Addendum #4

Troup County Board of Commissioners

Fire Station #1 - RFP (8/21/2026)

Burkes Chapel Road & Whitesville Road, Troup County, Georgia

3 KITCHEN 119 - EAST
A12.1 SCALE: 3/8" = 1'-0"

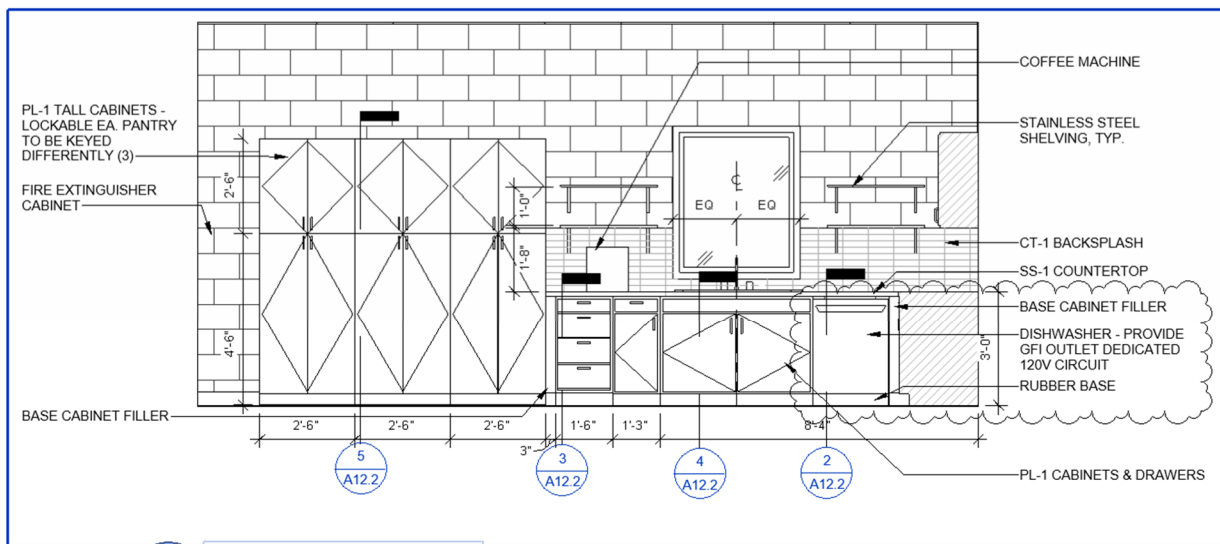
- 37 Approved Equal: Allow Draper Clutch-operated Flexshade NEXD as an approved manufacturer for roller shades
- 38 At Detail 9/A8.2, Architect will allow installation of matching thin brick on the inside returns of the overhead door jambs that align with the façade face brick
- 39 Add a dishwasher to the right of the kitchen sink in room 119. Provide an allowance of \$1,000 for appliance and installation similar to GE Profile 24" Smart Built-In Top Control Fingerprint Resistant Stainless Dishwasher w/ Microban Technology, 44dBA Model # PDT715SYVFS – Provide GFI outlet on wall behind dishwasher
